Concord Repatriation General Hospital Redevelopment (Stage 1) - Modification 4

Cooling tower relocation and minor design changes
State Significant Development Modification Assessment
(SSD 9036 MOD 4)

Published by the NSW Department of Planning, Industry and Environment

Figure 2: Relocated Cooling Towers (Source: Modification Report)

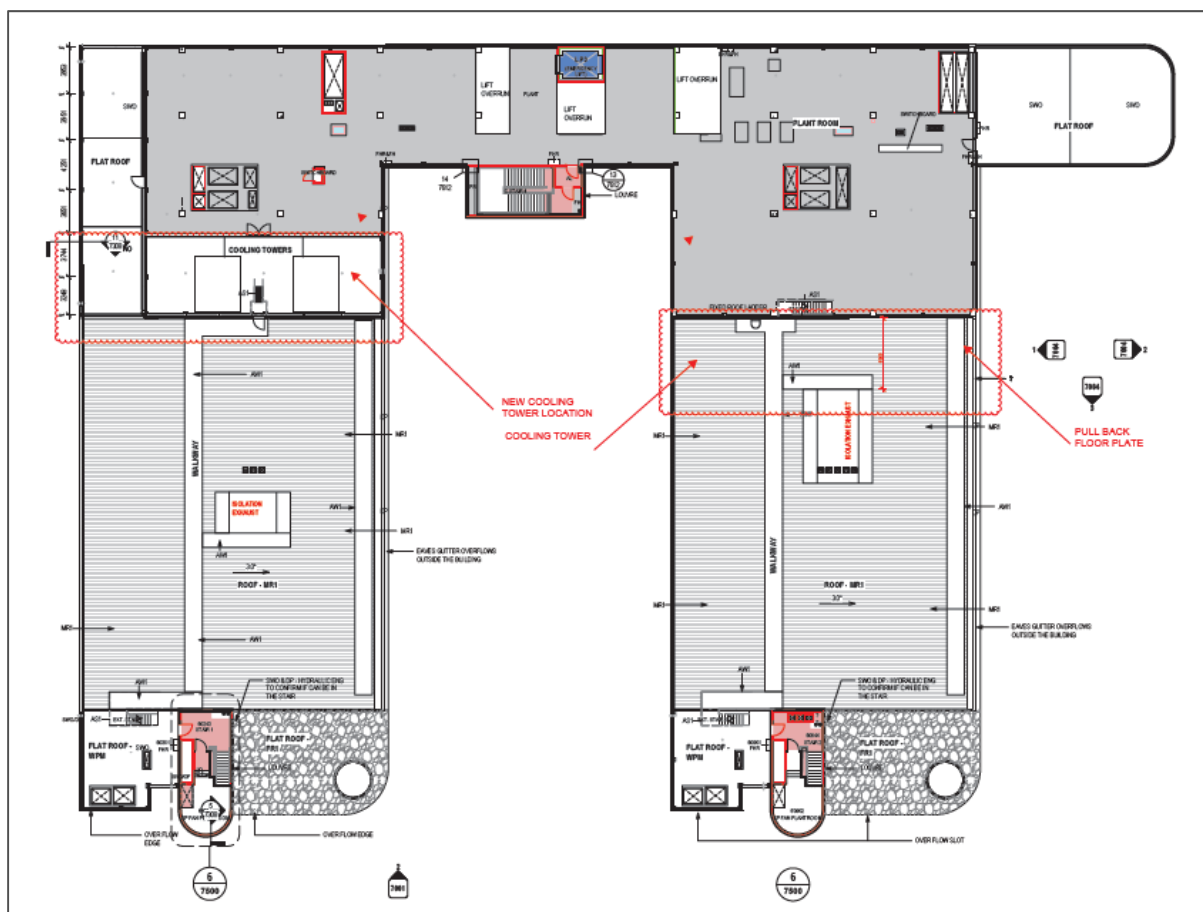
The modification application proposes to move the cooling towers and plant in the CSB to the western side of the building as shown in **Figure 2**. The current location of the cooling towers on the CSB is adjacent to the isolation room exhaust. The close proximity increases the risk of adverse microbial growth such as *Legionella*. The Applicant has requested the relocation in order to comply with Division 6 'Cooling water system' of the *NSW Public Health Regulation 2012*.

The design changes also include an extension of horizontal louvres around all facades of the CSB building, which increases the ventilation of the cooling tower plant located on Level 6.

The Department has reviewed the modification report and architectural plans detailing the justification for relocating the cooling towers and extending the louvres. The Department is satisfied that the

relocation is appropriate and provides a better outcome by lowering the risk of adverse microbial growth and improved ventilation to the cooling plant.

Figure 3: Helipad Covered Walkway (Source: Modification Report)

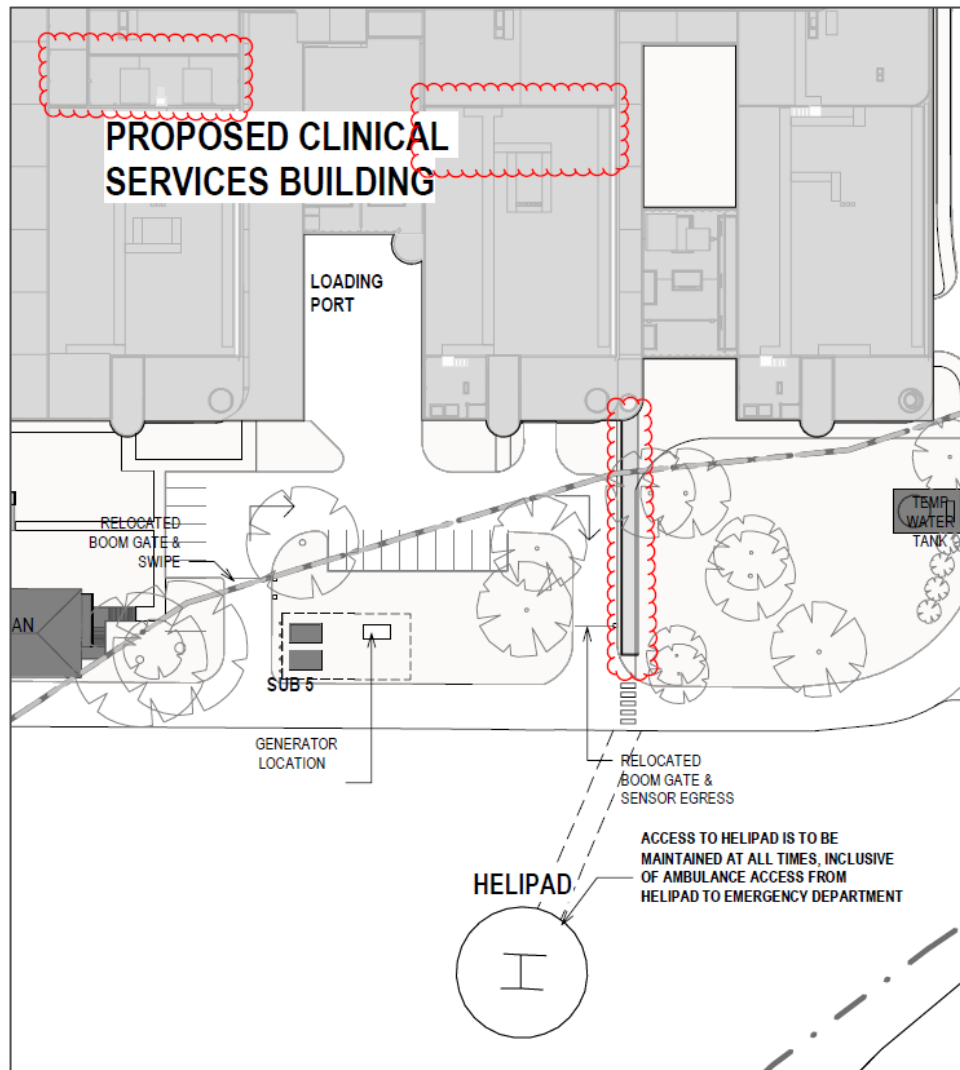
The modification application also seeks to upgrade the helipad walkway to the south of the site (**Figure 3**) that connects to the CSB. The provision of a covering will provide protection against all weather conditions and its inclusion is therefore supported by the Department.

Figure 4: Air Lock and Roof changes (Source: Modification Report)

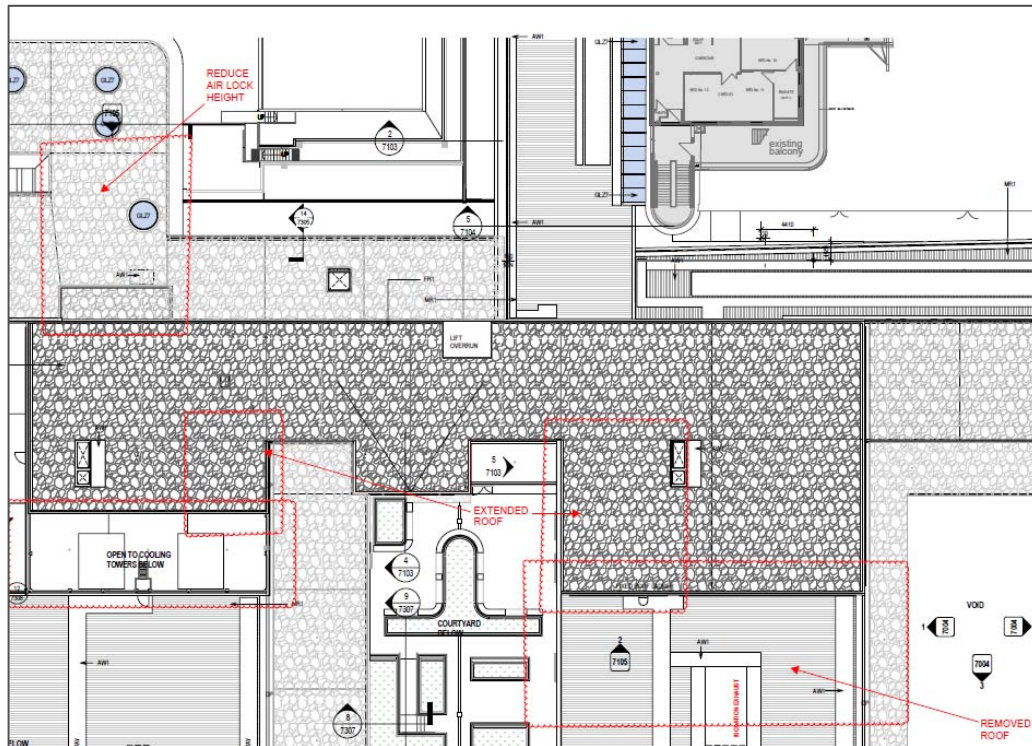
- reduction in the height of the airlock from two storeys to a single storey (**Figure 4**).
- landscaping at the south of the building portion (**Figure 5**).

- replacement of the Acrylic Render Façade System used on the northern, southern, eastern and western façades of the CSB with Reinforced Concrete Cladding to achieve fire-testing standards and improve public safety.
- minor amendments to glazing on facades including addition of green opaque colour back single glazing to the northern and southern façades.
- extension of roof to reflect changes to cooling tower relocation (**Figure 4**).
- removal of doors on ground and lower ground floor and replacement with windows.

The Department has reviewed the minor design changes in the modification application. The changes have been proposed to improve user amenity at the hospital and to improve safety. The cladding specifically has been updated to meet the relevant fire-testing standards and the Department is satisfied that there are no adverse visual impacts as a consequence of the proposed changes. The proposed amendments are therefore supported.
